Project	IEEE 802.16 Broadband Wireless Access Working Group < http://ieee802.org/16 >	
Title	MS handover to target MR-BS with transparent RS	
Date Submitted	2007-03-05	
Source(s)	<p>Kanchei (Ken) Loa, Yi-Hsueh Tsai, Chih-Chiang Hsieh, Yung-Ting Lee, Hua-Chiang Yin, Shiann-Tsong Sheu, Frank C.D. Tsai, Youn-Tai Lee, Heng-Iang Hsu</p> <p>Institute for Information Industry 8F., No. 218, Sec. 2, Dunhua S. Rd., Taipei City, Taiwan.</p> <p>[add co-authors here]</p>	<p>Voice: +886-2-2739-9616 loa@iii.org.tw</p>
Re:	IEEE 802.16j-07/007r2: "Call for Technical Comments and Contributions regarding IEEE Project 802.16j"	
Abstract	This contribution proposes procedures for MS handover to target MR-BS with transparent RS	
Purpose	Text proposal for 802.16j Baseline Document	
Notice	<p>This document has been prepared to assist IEEE 802.16. It is offered as a basis for discussion and is not binding on the contributing individual(s) or organization(s). The material in this document is subject to change in form and content after further study. The contributor(s) reserve(s) the right to add, amend or withdraw material contained herein.</p>

MS Handover to target MR-BS with transparent RS

Inset the foll

Figure xxx –MS scanning of neighbor access stations

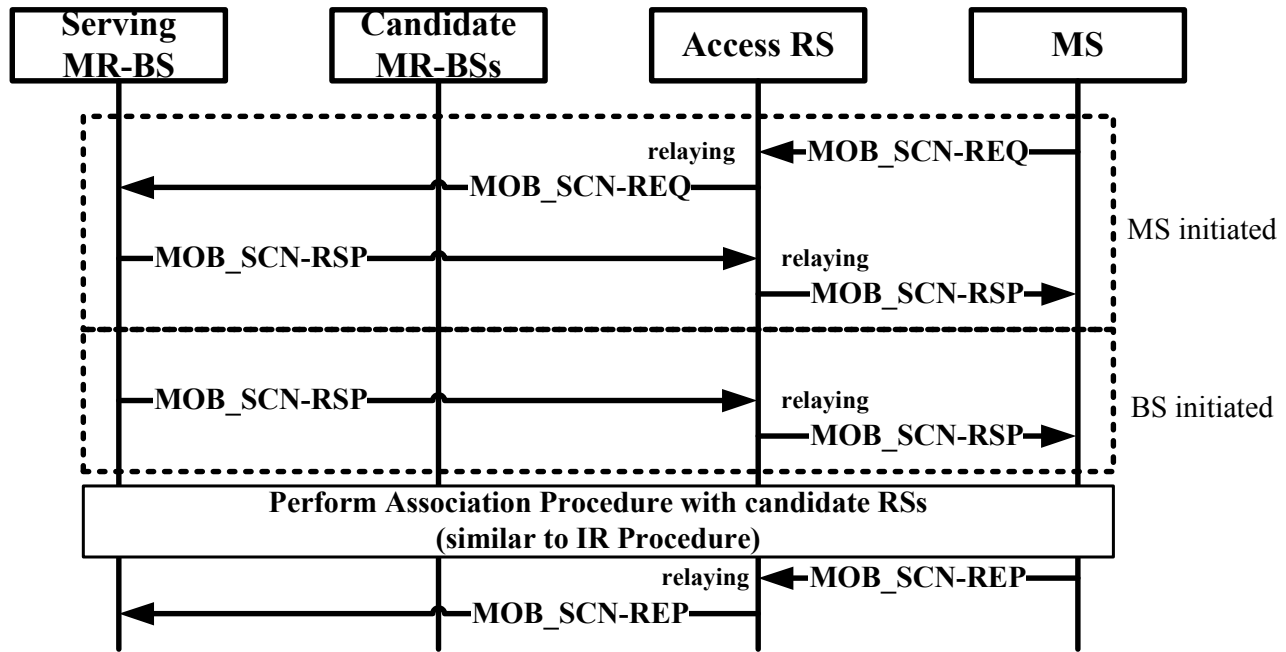
[A serving MR-BS may allocate time intervals to MS through access RS for the purpose of MS seeking and monitoring suitability of neighbor access stations as targets for HO.](#)

[Upon receiving MOB_SCN-REQ message from MS through access RS, the serving MR-BS may negotiate over the backbone with a BS recommended for Association allocation unicast ranging opportunities if the candidate access station is located at another MR-BS cell.](#)

[Upon reception of the MOB_SCN-REQ message through access RS, the serving MR-BS shall respond with a MOB_SCN-RSP message through access RS. The serving MR-BS may also send MOB_SCN-RSP message unsolicited through access RS.](#)

[The serving MR-BS may buffer the incoming data addressed to the MS during the scanning interval and transmit that data after the scanning interval during any interleaving interval or after exit of the Scanning mode.](#)

[If the serving MR-BS receives through access RS a MAC PDU message during any scanning interval from an](#)

MS that is supposed to be in Scanning Mode, the serving MR-BS shall assume that the MS is no longer in Scanning Mode. The group of intervals is terminated at any time if the MS sends MOB_SCN-REQ message to the serving MR-BS through access RS or serving MR-BS sends MOB_SCN-RSP message to MS through access RS during any interleaving interval with Scan Duration set to zero.

Figure xxx –MS Handover Initial and Decision

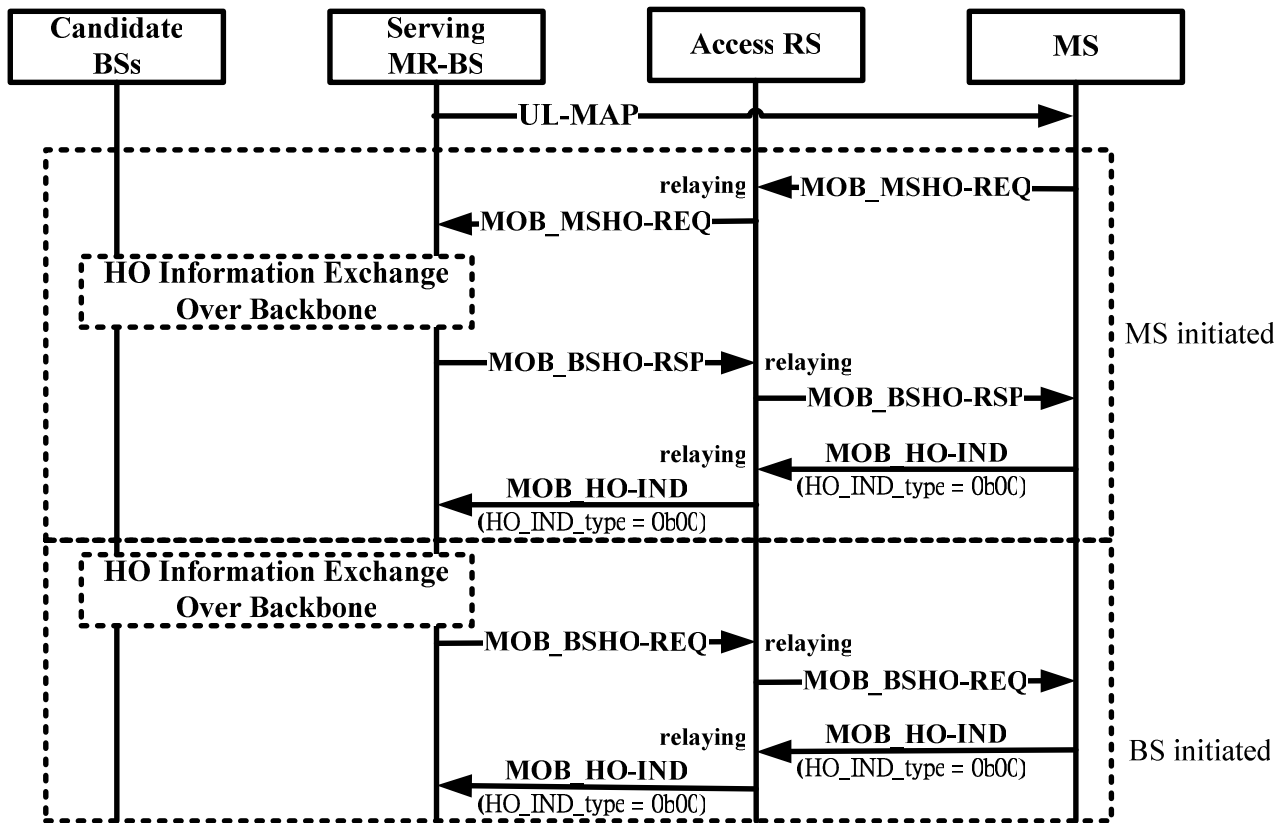
A handover begins with a decision for an MS to handover from a serving access station to a target access station. The decision may originate either at the MS, the serving MR-BS, or on the network. The HO may proceed with a notification through either MOB_MSHO-REQ or MOB_BSHO-REQ messages.

The serving MR-BS upon reception of the MOB_MSHO-REQ message through access RS, the serving MR-BS shall respond with a MOB_BSHO-RSP message through access RS. The serving MR-BS may also send MOB_BSHO-REQ message through access RS.

As an acknowledgement to the MOB_BSHO-RSP or MOB_BSHO-REQ message, the MS should send a MOB_HO-IND message through access RS.

Figure xxx –MS Network Entry/Termination of Handover

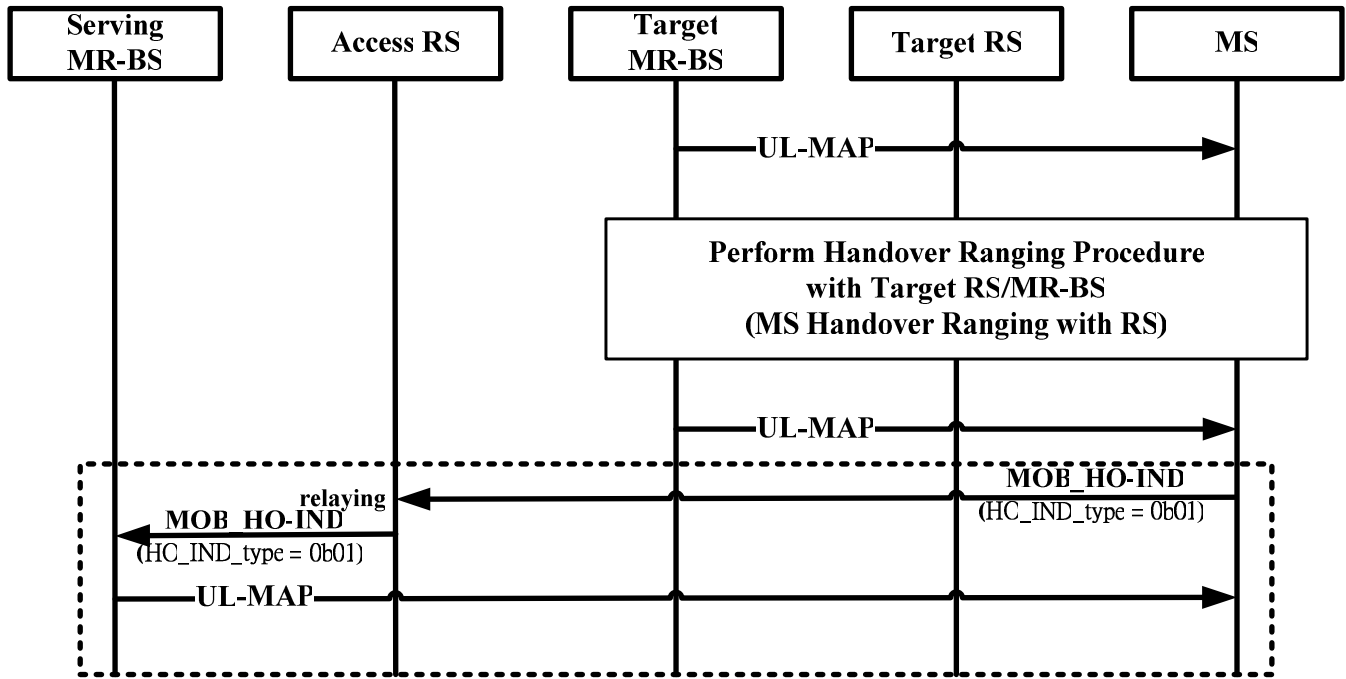
After an MS or serving MR-BS has initiated an HO using either MOB_MSHO-REQ or MOB_BSHO_REQ message, the MS may cancel HO at any time.

The cancellation shall be made through transmission of a MOB_HO-IND messages the HO cancel option (HO_IND_type=0b01).

When MS transmits and serving BS receives MOB_HO-IND message through access RS with the HO cancel

option (HO_IND_type=0b01) during Resource Retain Time (when Resource Retain Flag=1), regardless of MS attempt at HO, the MS and serving BS shall resume Normal Operation communication.
